Property Address: 2808 E Leigh St, Richmond, VA 23223 Current Zoning: Residential  
Historic District: Church Hill North

Restore, repair, and replace (where items and materials are beyond restoration) the front of the house including new windows (in keeping with the original look), insulation, exterior trim, dental molding, soffits, gutter area, roof rafter ends, siding (Installing a like-kind wood siding), framing repair as needed, and primer and paint (approved

# CERTIFICATE OF APPROPRIATENESS

**From:** [Mandy Derby](#)  
**To:** [Dandridge, Alex - PDR](#)  
**Cc:** [Christopher Wingfield](#)  
**Subject:** Re: 2808 E Leigh St -- seeking approval for alterations/repairs  
**Date:** Friday, April 19, 2024 4:55:23 PM  
**Attachments:** [image002.png](#)  
[image005.png](#)  
[image003.png](#)

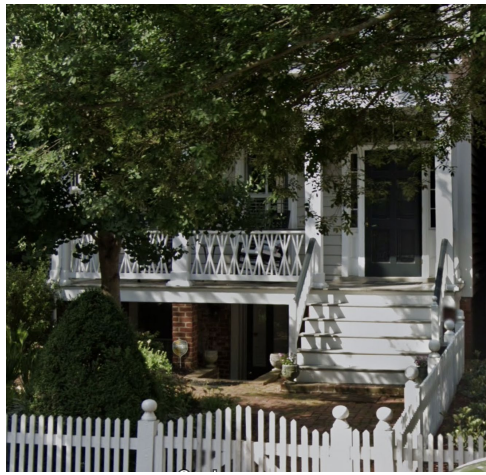
For the May 28th meeting, is there any more information you need from me that will help with our approval process? I just spoke to Chris and he'll be sharing with you the material specs for the window replacements (in-kind in material, style, and proportions to the originals).

We've read the guidelines, as has Chris, and our goal is to maintain and restore the historic look of the house as we improve its quality and make updates. Many of the elements on the facade are rotted beyond repair and despite being recently renovated (2018 I believe), the house -- especially the front -- is in poor condition. It seems, at the time, many cosmetic updates were made when deeper renovations and repairs were needed.

We're investing in the house to mend it, care for it, and make it more efficient. In almost every area of this front facade project, we're in keeping with the identical historic appearance and materials. There are just two elements we'd like to update that are still historically accurate, appropriate, and relevant to the period of the house -- just not *identical* to the original house: the siding height and the railing style. As the owners who are making the investment to improve the property, it would be great to also *like* the updates. Is there some leeway between historically appropriate and historically identical? According to my research, our house is a Colonial Revival architecture style. I'm seeing many houses in the neighborhood of the same style with taller siding on their primary elevations. We'd like to use 7 1/4" if possible. For the railings, we're taking cues from our original front fence and inspiration from other traditional Colonial Revival houses in the neighborhood to create a railing style that's still historically relevant, though not identical -- and a style we feel good spending our money to create. We'd also be keeping the original columns and are seeing this balustrade railing used with our same column style.

Because you are wanting to install a different siding type on the facade, as well as a new railing style, this application is lending itself more towards a full Commission Review. I can go ahead and schedule it for the May 28<sup>th</sup>, 2024 CAR meeting.

I will add that generally alterations that are made on historic building should be in-kind or based on physical or photographic documentation, which is also reflected in our guidelines. I can see if I have any older photos in our files if you wish to take inspiration from that.

All this being said, your present this to the commission, but there will be some discussion and push back on changing the siding on the front and adding a new railing.

Just found this picture in our files from 2016 that shows the faux brick siding coming off, revealing the wood siding underneath. Looks like it was a faux brick!

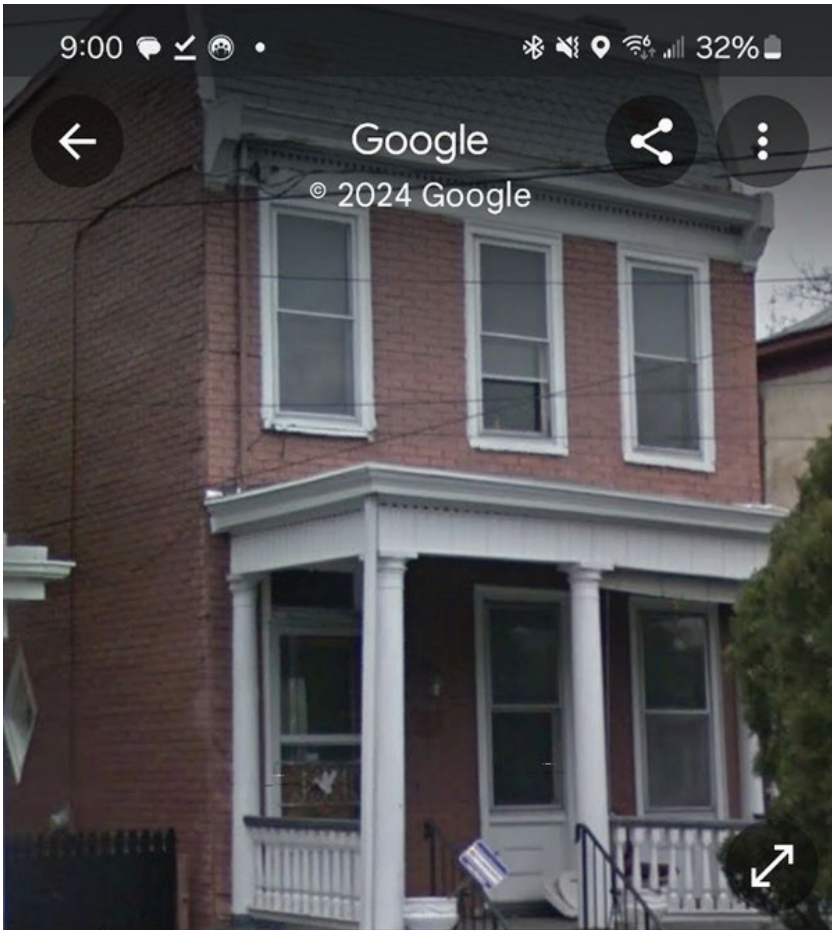
That's wild. Thanks for sharing. We thought the house was originally brick and then sided in 2016. We wondered why the siding was in such disrepair!
